THE CLEVELAND ELECTRIC ILLUMINATING CO.
 PERRY NUCLEAR POWER PLANT UNITS 1 & 2
 ELECTRICAL-ELEMENTARY DIAGRAM
 CONTROL ROOM ANNUNCIATOR
 COMMON HVAC PANEL (H13-P704)

E L E M E N T A R Y A N N U N C I A T O R W I R I N G R 6 1 - 6 1 1

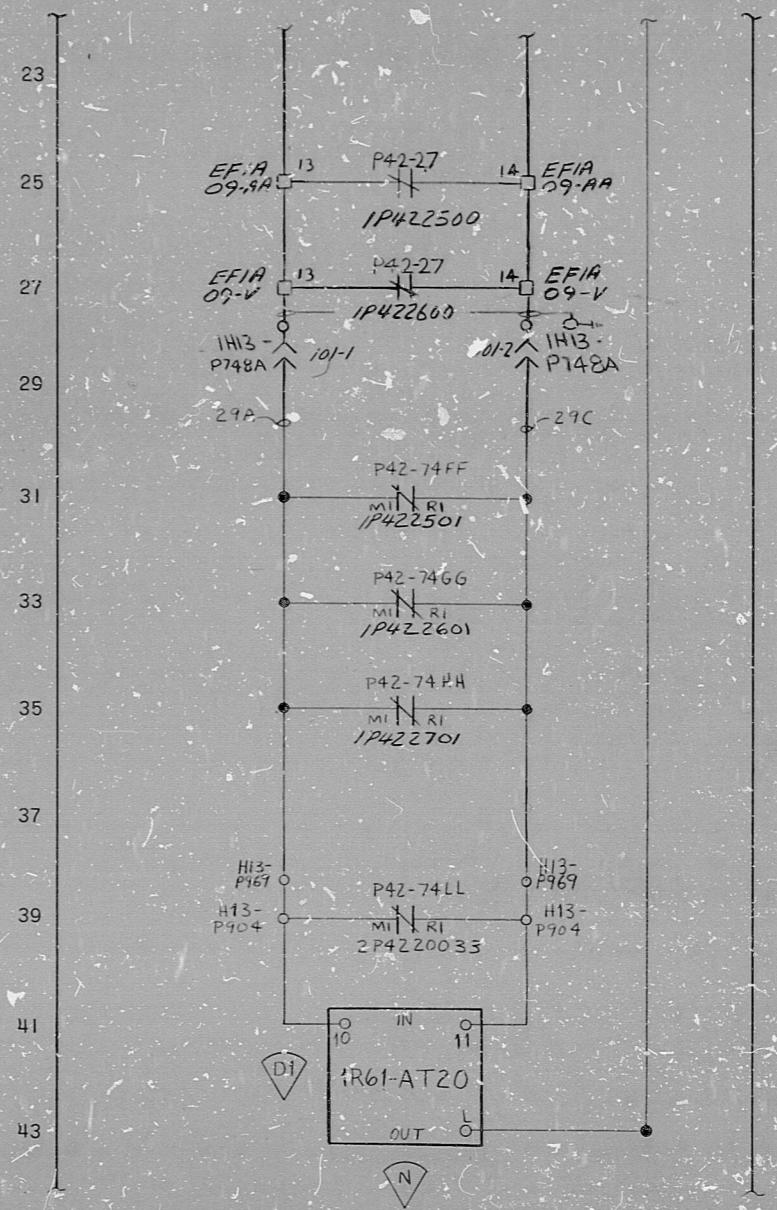
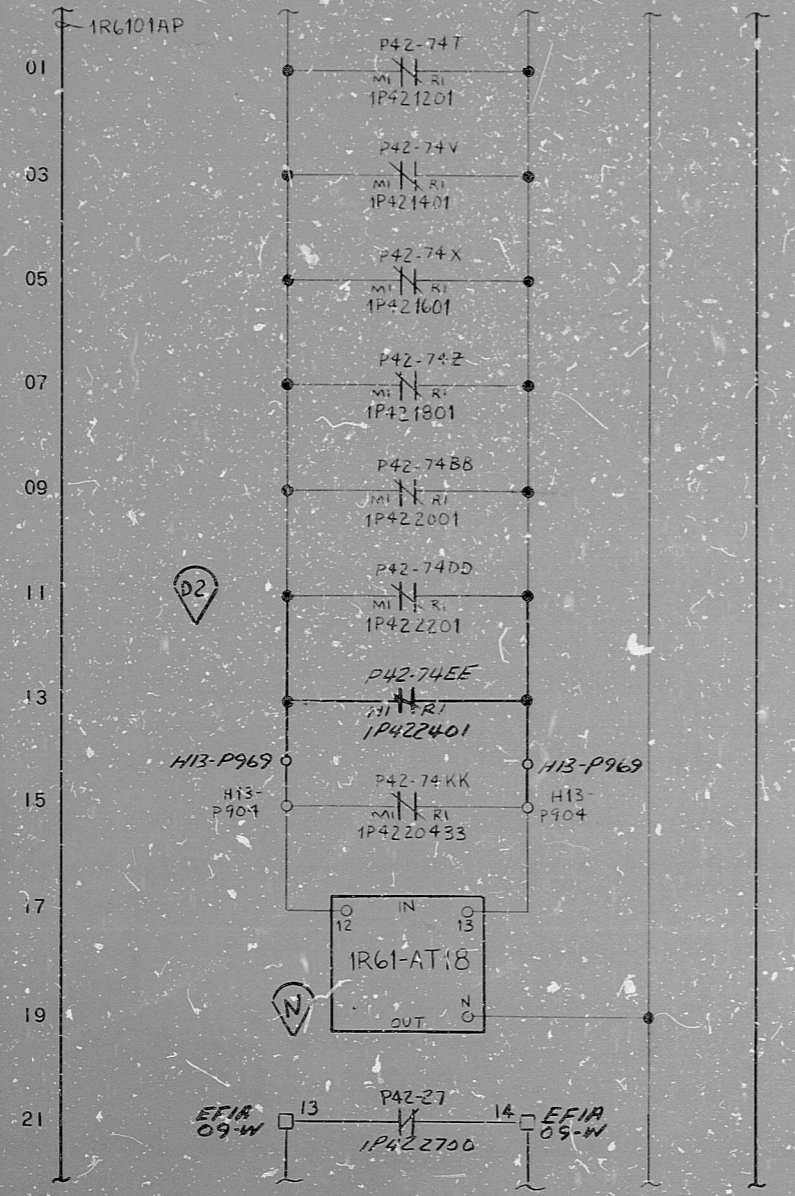
WCR 1286
 ECN-245-033-01-449
 MOVE LN 29 TO LN 13
 DIV 1 TO DIV 2, U2 TO #1
 DELETE LN 23
 CHANGE LNS 21, 25, 27
 CHANGE PER LN 31, 33, 35

REV PER ECN 245-033-01-149
 ADD EAY ASSIGN #
 TERMINAL INFO TO
 LN 28

REV PER ECN 245-033-01-149
 MOVED 27 CONTACT FROM
 LINE 37 TO LINE 21
 ADDED MCC SYMBOLS &
 UNIT INFO, ADDED
 FIELD CIRCUIT LN 29

REV PER ECN 245-033-01-149
 ADDED P42-27 TO LINES
 23, 25, 27 & 37
 ADDED BACK-LOGIC
